Access Compliance Report

Public Rights-of-Way

(Curb Ramps)

Intersection ID: 30017	Main Street: GREENBANK_CT	Cross Street: OLD_CAROLINA_DR	Location: E
ADA ID: C7B479FFFB39	Ramp Type: PerpDiag	Initial Pass/Fail: Fail	Overall Compliance: No
Severity Score: 37.5			
Codes/Mitigation Info/Possible Solution		Field Measurements/Component Compliance

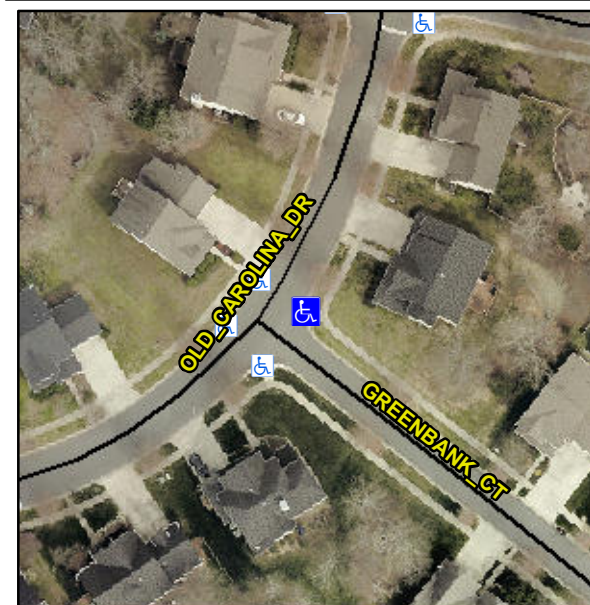
Not Found, R304.2.2, R304.5.3

Compliance	Description	Data	Compliance	Description	Data
N/A	Ramp Length (in)	86.0	No	Ramp Slope (%)	8.8
Yes	Ramp Width (in)	59.0	No	Ramp XSlope (%)	7.7
N/A	Flare Type LT	N/A	N/A	Flare Type RT	N/A
N/A	Flare Slope LT (%)	N/A	N/A	Flare Slope RT (%)	N/A
N/A	Flare Traversable LT?	N/A	N/A	Flare Traversable RT?	N/A
N/A	Landing Length (in)	N/A	N/A	DWS Provided?	N/A
N/A	Landing Width (in)	N/A	N/A	DWS Contrast?	N/A
N/A	Landing Slope (%)	N/A	N/A	DWS Length (in)	N/A
N/A	Landing X Slope (%)	N/A	N/A	DWS Full Width?	N/A
N/A	Landing Curb? (Y/N)	N/A	N/A	DWS Offset (in)	N/A
N/A	Shared Landing?	N/A			
N/A	Gutter Ponding?	N/A	N/A	Gutter Slope (%)	N/A
N/A	Gutter Lip Ht (in)	N/A	N/A	Gutter X Slope (%)	N/A
N/A	Painted X Walk1?	No	N/A	Painted X Walk2?	No
	X Walk 1 Direction	To NW		X Walk 2 Direction	To SW
N/A	X Walk 1 Width (in)	N/A	N/A	X Walk 2 Width (in)	N/A
	X Walk 1 Slope (%)	6.8		X Walk 2 Slope (%)	1.1
	X Walk 1 X Slope (%)	2.7		X Walk 2 X Slope (%)	4.3

Remove & Replace Curb Ramp With Two New Directional Ramps or Equivalent.
